# Product Information News

## AIRFRAME CYLINDER BAND ADJUSTMENT LATCH

**Figure 1: (Left view) Acceptable**

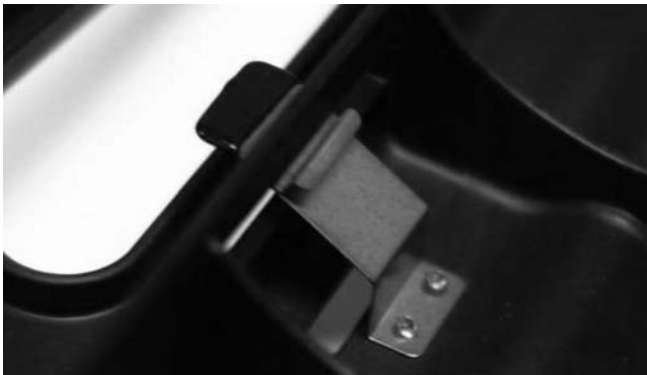
In conjunction with the annual flow test and inspection, be sure to check the cylinder band adjustment latch (see figure 1) for damage. If excessive stress is applied to the latch, it can become bent and may not properly retain the metal cylinder band. If the latch appears to be bent, or the hook is outside of the vertical carrier rail (see figure 2) replace the latch with P/N 10066867, according to the following procedure. The new latch has been made of a more rigid material to prevent against this damage.

The metal cylinder band tab is *inside* of the vertical carrier rail and is not bent or deformed.

The metal tab is *outside* of the vertical carrier rail and noticeably bent or deformed.

1. Remove the cylinder from the SCBA and unhook the cylinder band from the adjustment latch.
2. Using a 1/8" drill bit, remove the two aluminum rivets that retain the latch to the carrier.
3. Inspect the two holes in the backplate for deformation.

**Note:** If the holes are not uniform or appear enlarged, remove the carrier from service.

4. Install the new latch (P/N 10066867) with a general purpose pop-rivet gun, using the rivets provided (P/N 10058780).
5. Inspect the installed latch to verify that:
  - a. It is securely retained to the carrier
  - b. It is positioned properly
  - c. It is tight and flat against the backplate
